January 24, 2003
L-03-004

**Subject: Beaver Valley Power Station, Unit No. 1 and No. 2
BV-1 Docket No. 50-334, License No. DPR-66
BV-2 Docket No. 50-412, License No. NPF-73
Reply to Request for Additional Information Regarding
60-Day Response to Bulletin 2002-01**

Reply to Request for Additional Information Regarding Beaver Valley Power Station (BVPS) Units 1 and 2 60-Day Response to NRC Bulletin 2002-01 “Reactor Pressure Vessel Head Degradation and Reactor Coolant Pressure Boundary Integrity”

Figure 4A

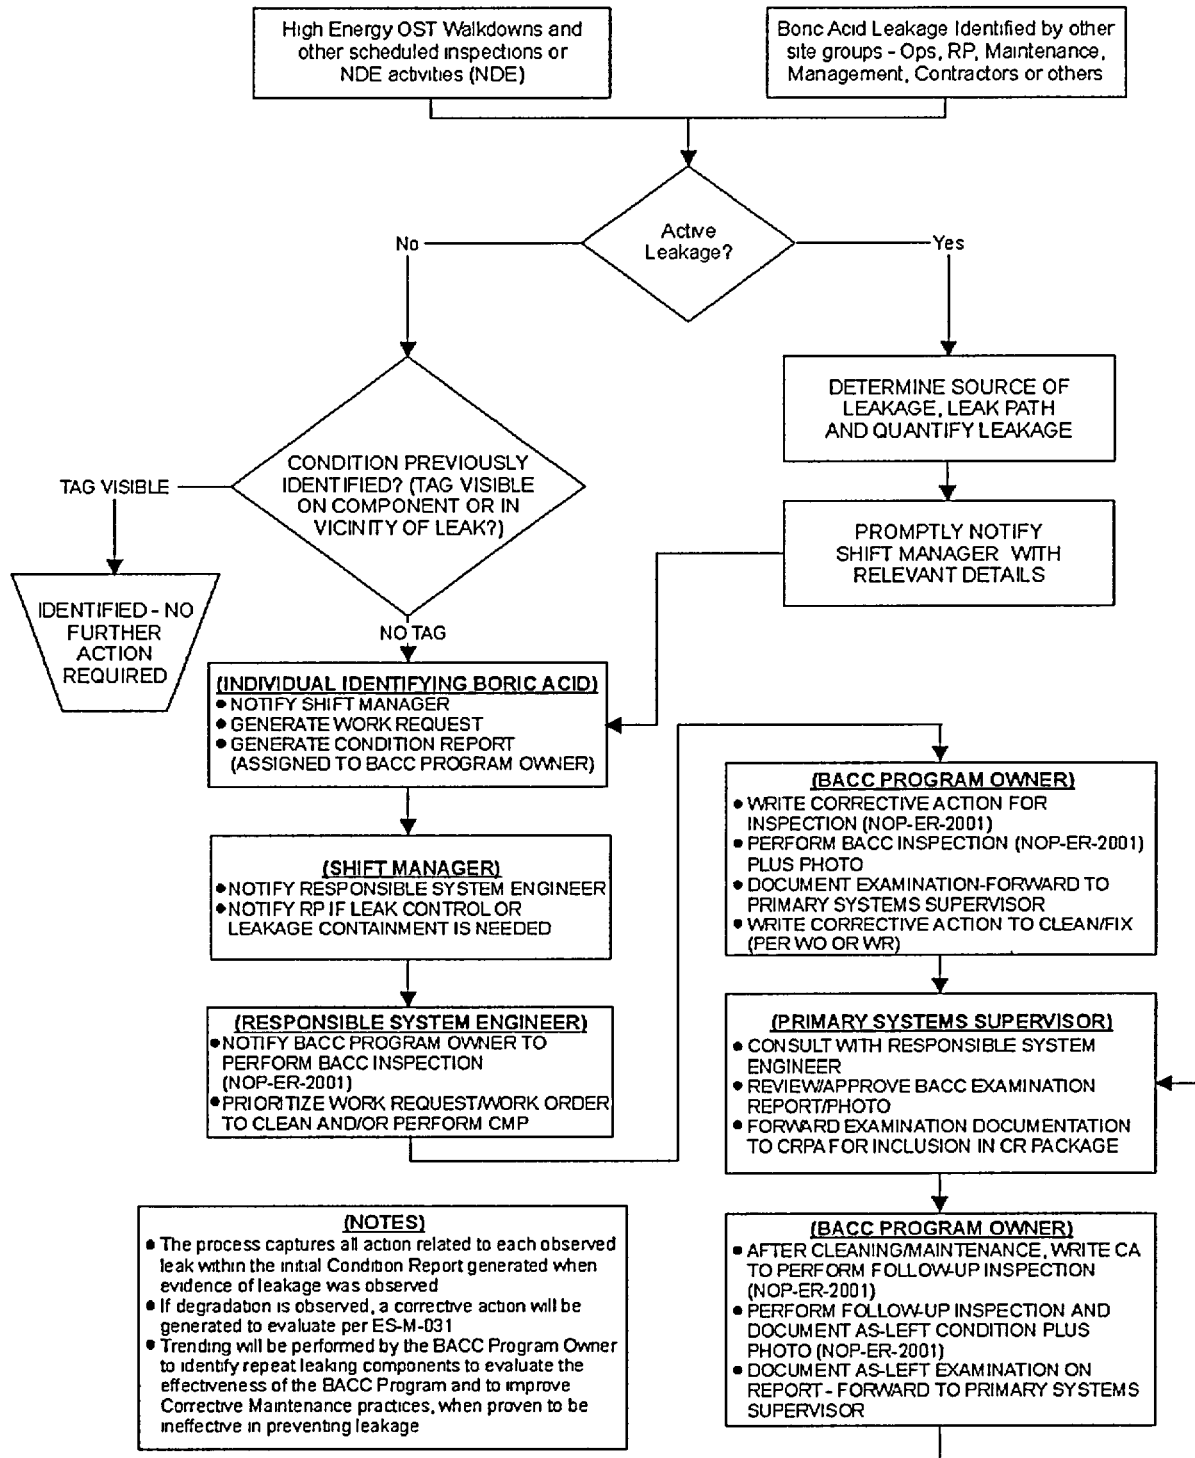
4. ***Describe the evaluations that would be conducted upon discovery of leakage from mechanical joints (e.g., bolted connections) to demonstrate that continued operation with the observed leakage is acceptable. Also describe the acceptance criteria established to make such a determination. Provide the technical basis used to establish the acceptance criteria. In addition,***
 - a. ***if observed leakage is determined to be acceptable for continued operation, describe what inspection/monitoring actions are taken to trend/evaluate changes in leakage, or***
 - b. ***if observed leakage is not determined to be acceptable, describe what corrective actions are taken to address the leakage.***

Boric acid leakage process flow charts were developed for inclusion in 1/2-ADM-2112, "Boric Acid Corrosion Control," and are attached for your information (see Figures 4A and 4B). These flow charts clearly identify the process and the actions to be taken.

If the observed leakage is determined to be acceptable for continued operation, the actions and monitoring for trending and evaluating are described in our procedure 1/2-ADM-2112. A summary of the process is provided in the attached flowcharts (see Figures 4A and 4B).
